**Agency:** U.S. Nuclear Regulatory Commission  
Advisory Committee on Reactory Safeguards

**Title:** Subcommittee On FTOL Conversions

**DATE:** Wednesday, December 5, 1990 **PAGES:** 1 - 98

Subcommittee on FTOL Conversions

CYCLE 9 PERIPHERAL LOADING PATTERN

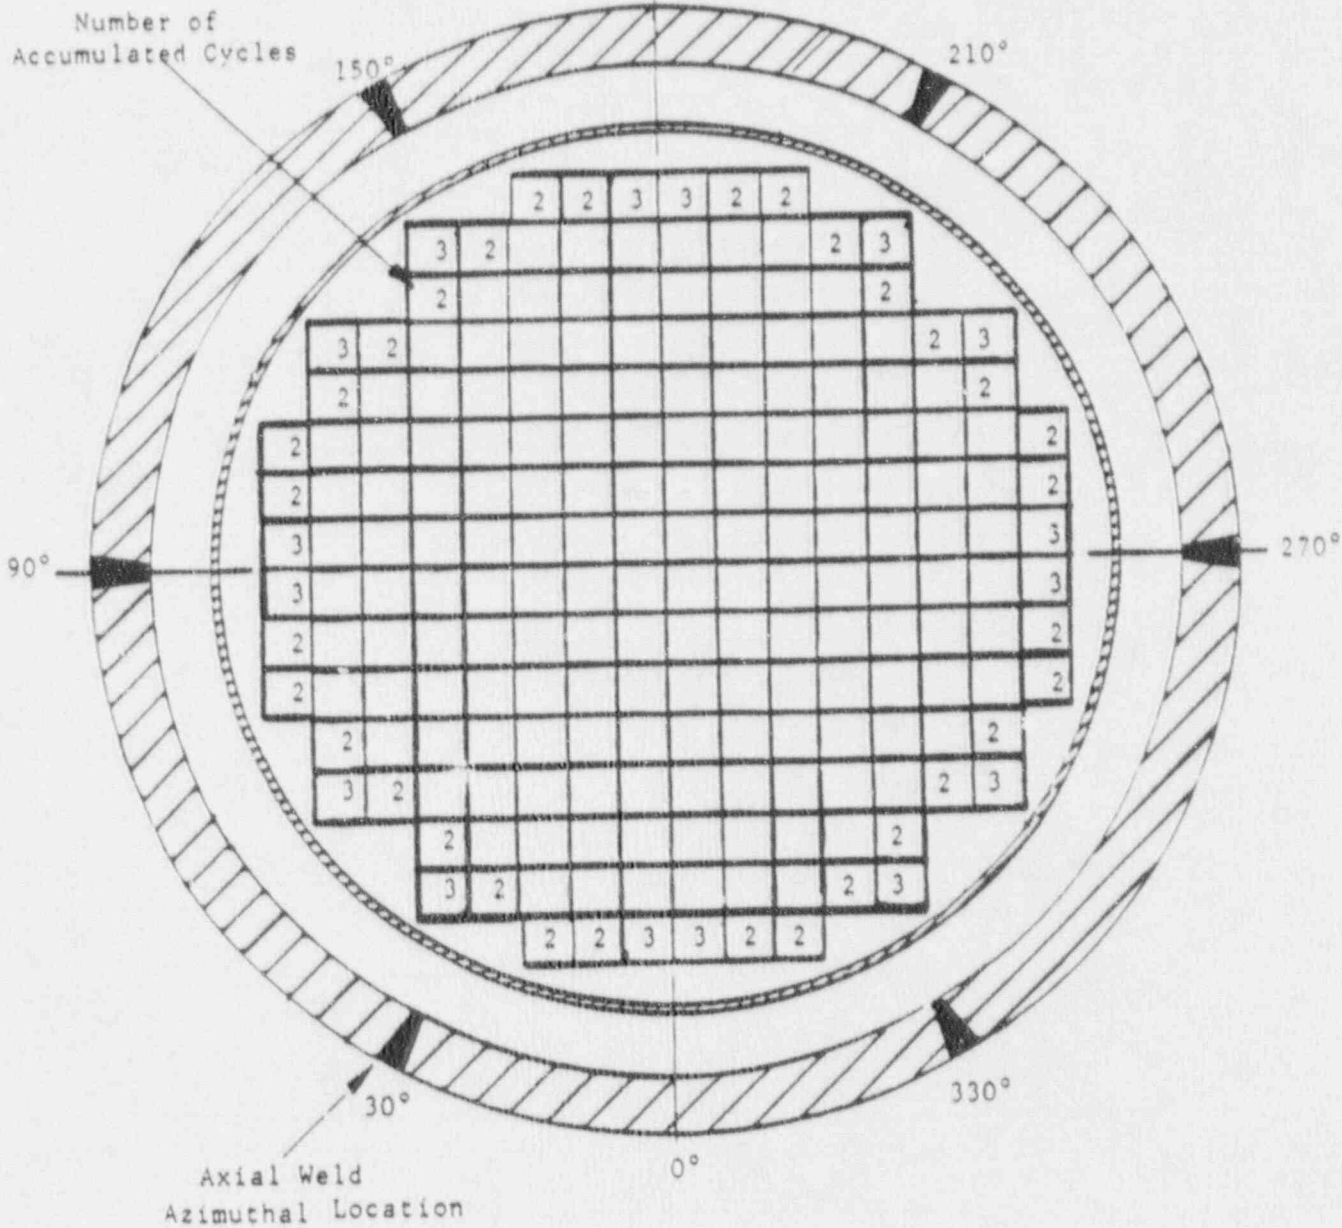
1 MR. SIESS: On that figure where you showed the  
2 fuel layout, you have two's and three's. It says that the  
3 three's are thrice burned, and could I assume that the two's  
4 are twice burned?
